Re:
1320 Hollywood Blvd
Hollywood, Florida 33019
Architect's Project #25075

DUBEY HISTORIC RESIDENCE
 1320 HOLLYWOOD BLVD
 HOLLYWOOD FLORIDA 33019

PLANNING COMMENTS | URJA MODI | umodi@hollywoodfl.org

1 SITE PLAN
 1/8" = 1'-0"

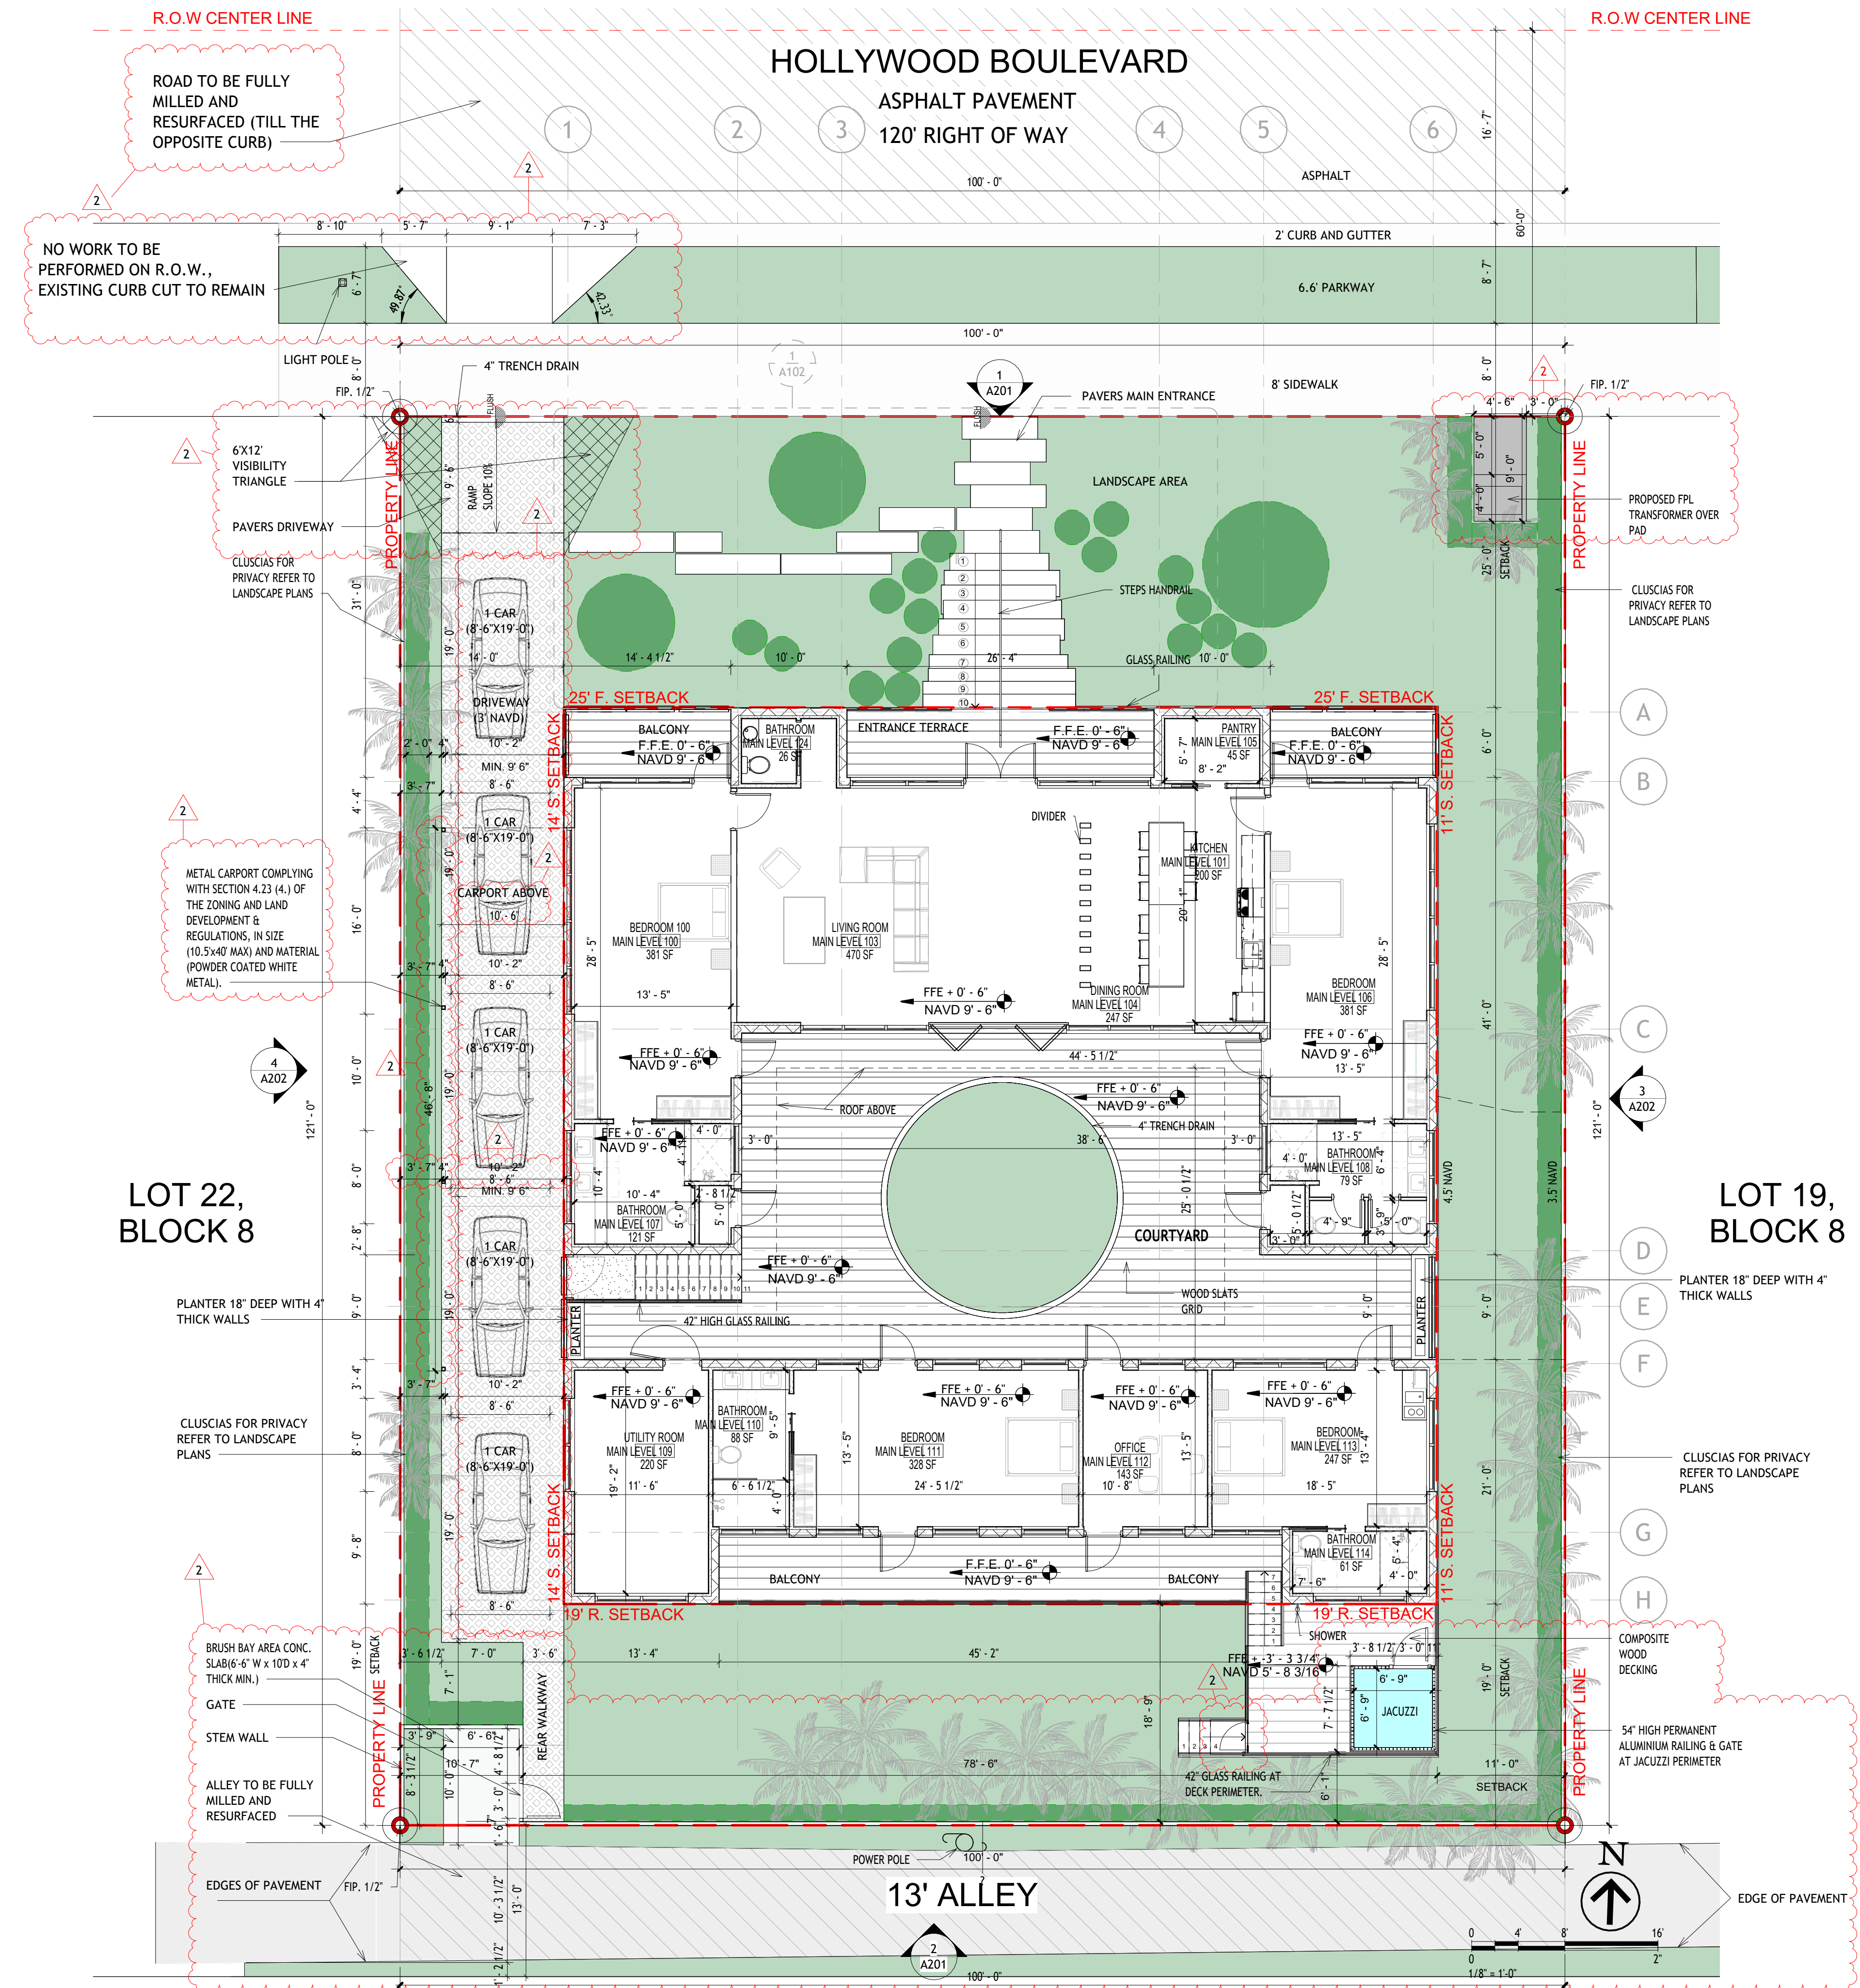
1. The zoning table provides incorrect information regarding the required side setback – please correct. Side/Interior setback requirements are as follows: The sum of the side yard setbacks shall be at least 25% of the lot width, but not to exceed 50 ft. with no side yard less than 7.5 ft.; except, platted and recorded lots of 50 ft. or less in width may have a 5 ft. setback (only applies to one story additions and new construction of one story buildings). Any construction in excess of one story must meet the 25% rule with a minimum 7.5 ft. setback.

2. Rear and front setbacks for the primary building are missing on the site plan.

3. Parking spaces must be marked and dimensioned on the Site Plan.

5. Add row to site data / zoning table specifically indicating proposed floor area.

6. Add parking requirements, calculations and proposed values to the site data / zoning table.

7. Provide pervious/impervious area percentages and calculations for entirety of site to site data / zoning table. A minimum of 40% of the overall site is required to remain as pervious area. Based on the current pervious area value provided (4,614.84 SF) calculated against the lot area (12,106 SF), a pervious area of approximately 38% is being proposed. Should this be accurate, a variance application subject to approval by the Historic Preservation Board will be required.

8. Additionally, add the pervious/impervious area percentages and calculations for front yard to the site data / zoning table. Please indicate the front with graphics on the site plan.

10. Dimension brush bay area on Site Plan (must be located within property boundaries). Minimum size of brush bay area is 3-feet by 6-feet.
RESPONSE: Brush Bay Area redimensioned to comply MIN. 3'x6'. REF: SHEETS A100 & A101.

15. Indicate curb cuts with dimensions on Site Plan.
RESPONSE: Curb cuts dimensioned on Site Plan. REF: SHEET A100.

16. Indicate driveway aprons radius on Site Plan.
RESPONSE: Driveway aprons radius indicated on Site Plan. REF: SHEET A100.

17. Illustrate connection to sidewalk on Site Plan.
RESPONSE: Connection to sidewalk illustrated on Site Plan. REF: SHEET A100.

H. Provide sight visibility triangles for all driveway access per Chapter 155.12 of the city code on the site plans and civil plan sheets. Be sure to label the distance between the edge of pavement and the property line including both sides of the triangle.

J. Please show the distance from the interior face of the column for the carport to the exterior of the structure, ensure a minimum clear space of 9'-6" is maintained for the vehicle.

RESPONSE: Required Setback correct at Zoning Table. REF: SHEET A100

RESPONSE: Rear and Front Setbacks for the primary building now shown. REF: ARCH. PLANS.

RESPONSE: Parking Spaces marked and dimensioned on the Site Plan. REF.: SHEET A100

RESPONSE: R.O.W. added to Zoning Table.

RESPONSE: Parking Requirements added.

RESPONSE: Pervious/Impervious Areas adjusted to comply the MIN. 40% required.

RESPONSE: Front Yard Pervious/Impervious Areas shown. REF: SHEET A100.

RESPONSE: Sight Visibility Triangles shown. REF: SHEET A100.

RESPONSE: Carport Interior clear space shown 9'-8". REF: SHEET A100.

1 NORTH ELEVATION

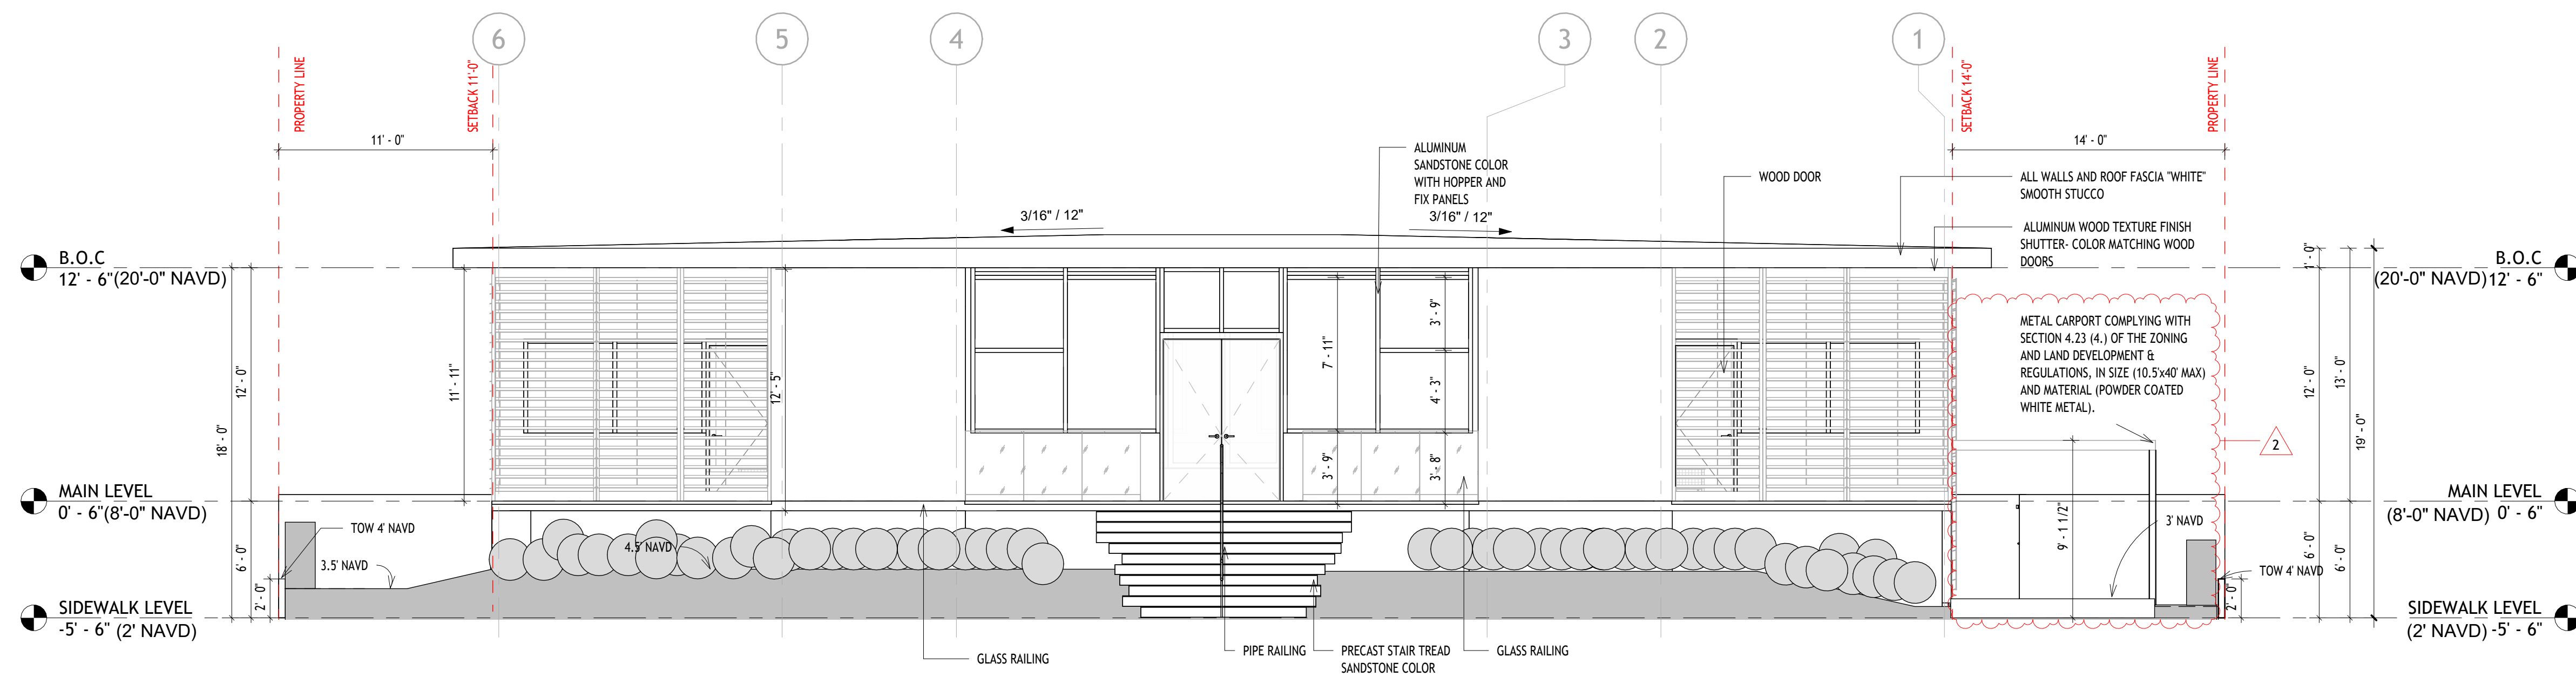
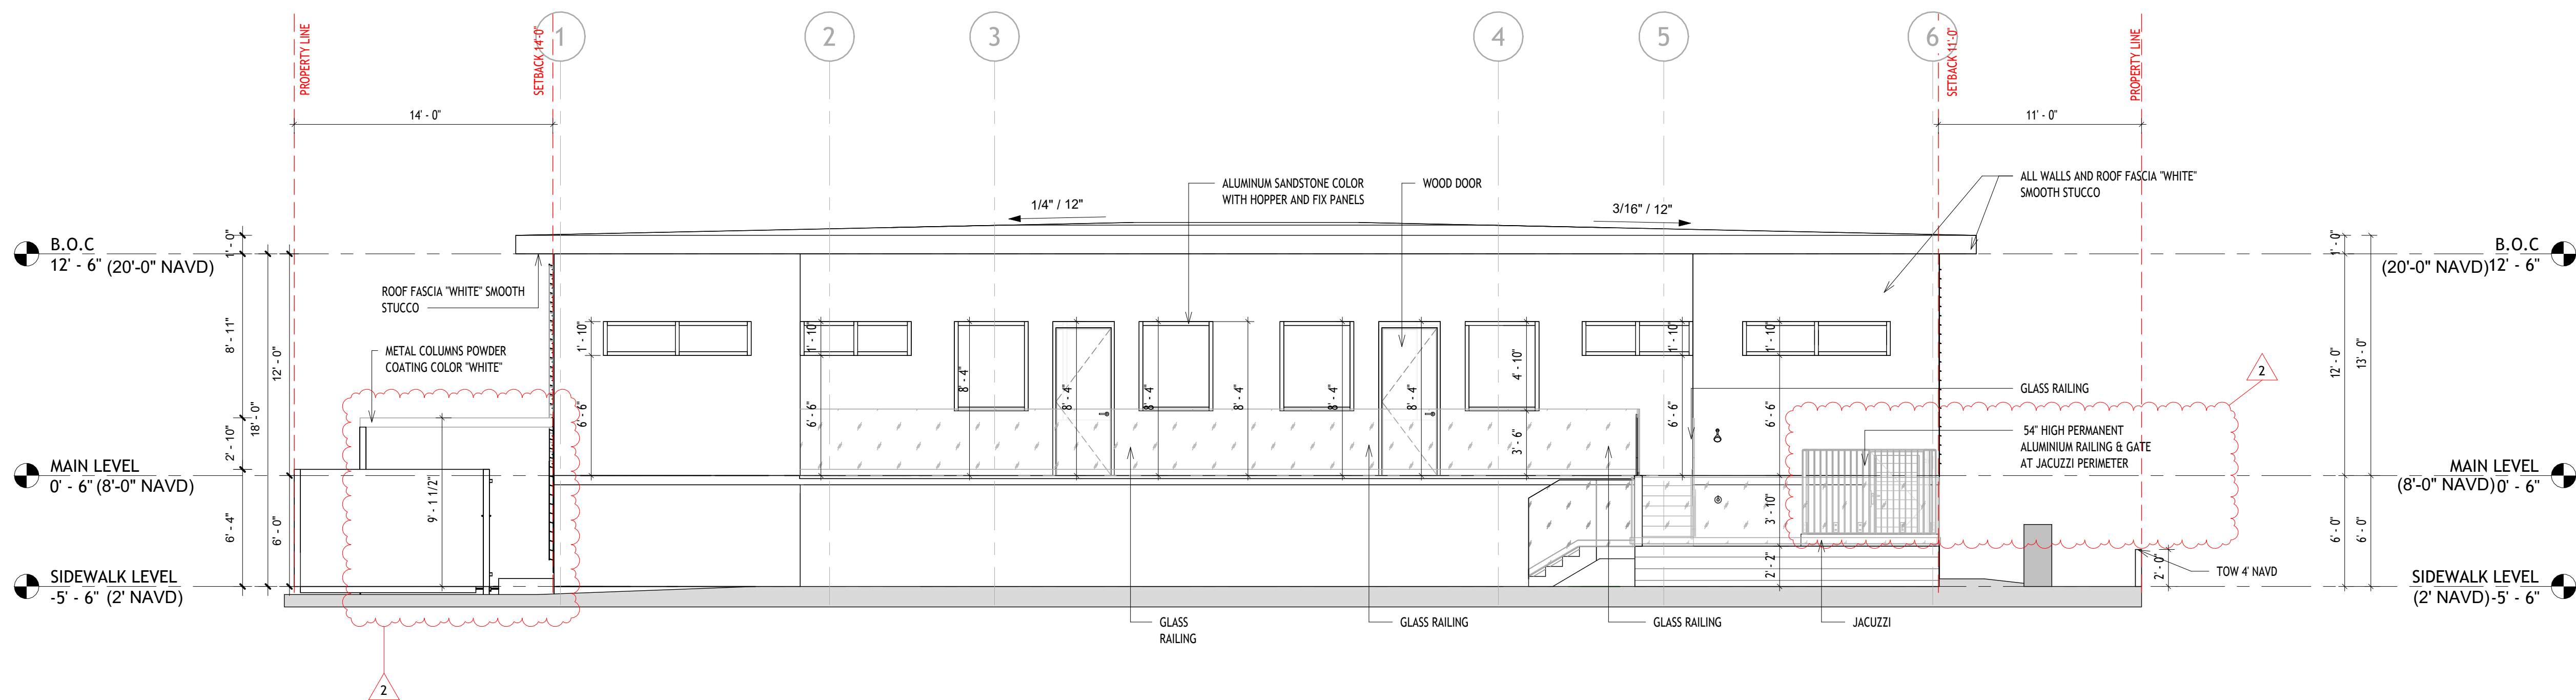
1. Provide additional measurement of total height after FEMA

RESPONSE: Total Height Measurement added. REF: SHEET A201.
